CHANGE NOTICE

IS-GPS-800 Rev F

PCN-IS-800F_RFC403

CLASSIFIED BY: N/A**DECLASSIFY ON:** N/A**Document Title:** NAVSTAR GPS Space Segment/User Segment L1C Interface**RFC Title:** Health Bit Clarification**Reason For Change (Driver):**

Figure 3.5-7. Subframe 3, Page 6 - Text

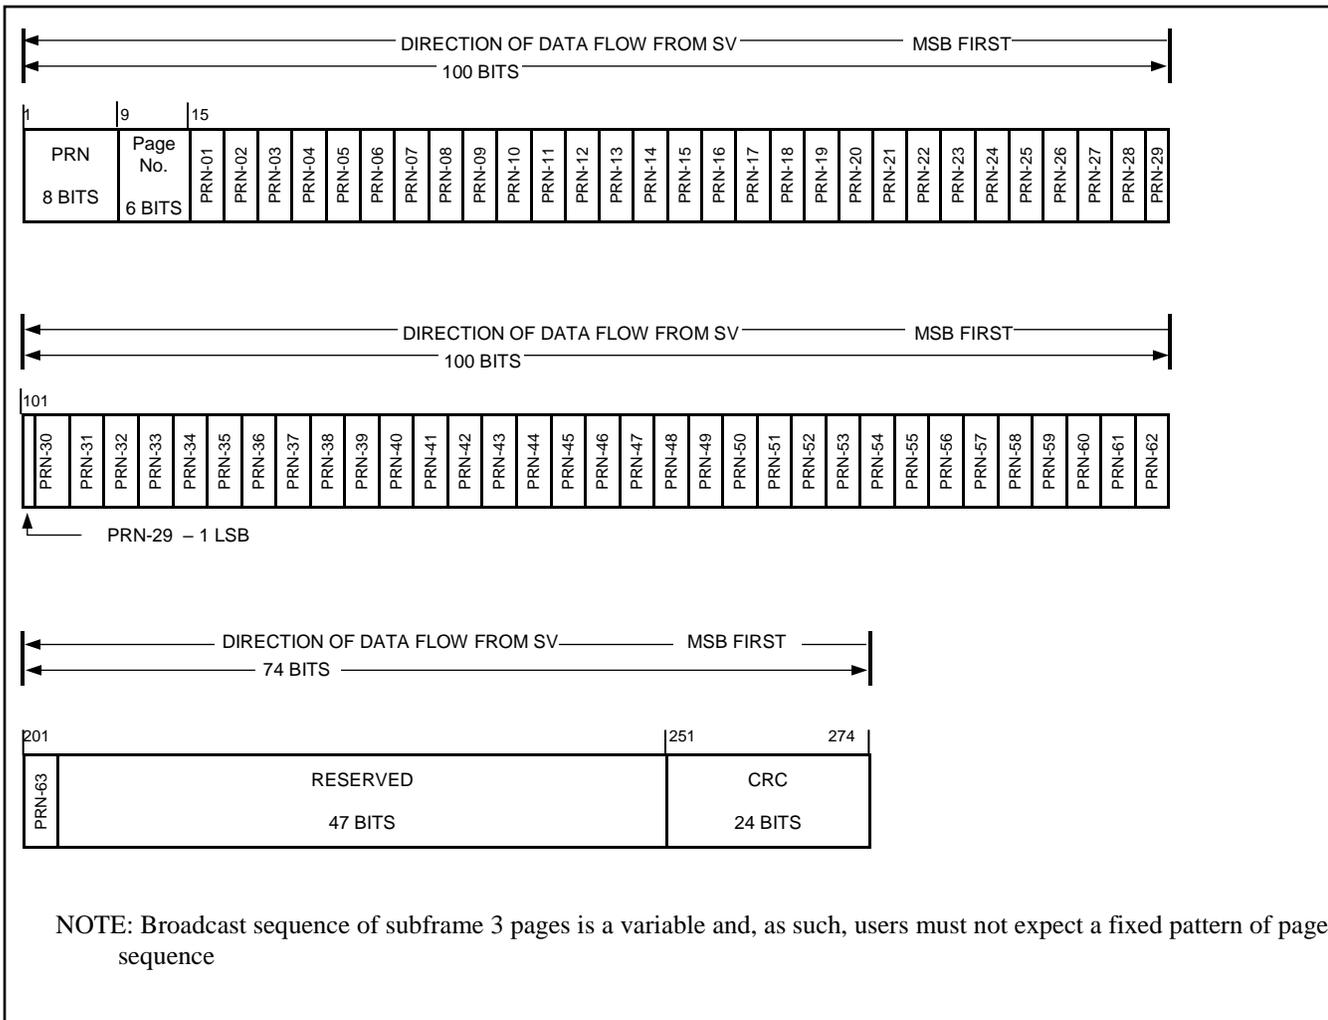
<INSERTED OBJECT>

Add figure for SV Configuration on CNAV-2

Figure 3.5-11. Subframe 3, Page 7 - SV Configuration

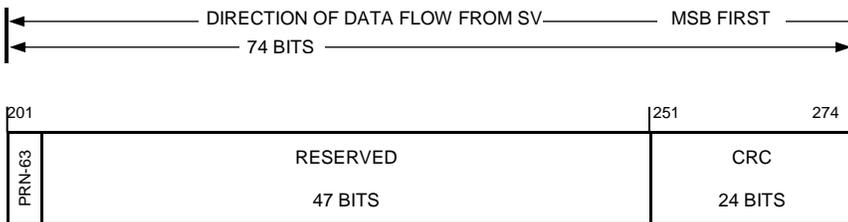
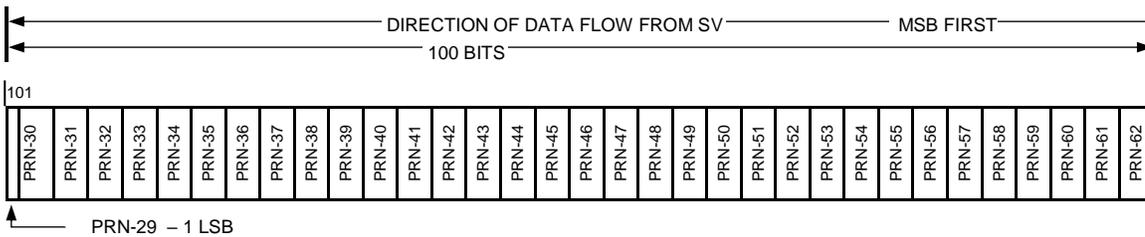
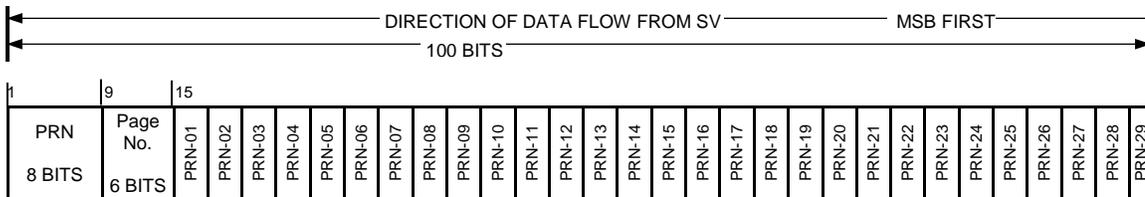
Add new figure for SV Configuration on CNAV-2

Add information for SV Configuration on CNAV-2

Subframe 3, page 7, as depicted in Figure 3.5-11, contains a three-bit long term for each of up to 63 SVs to indicate the configuration code of each SV.

The 63 three-bit-long terms shall indicate the configuration of each SV using the codes as defined in paragraph 20.3.3.5.1.4 of IS-GPS-200.
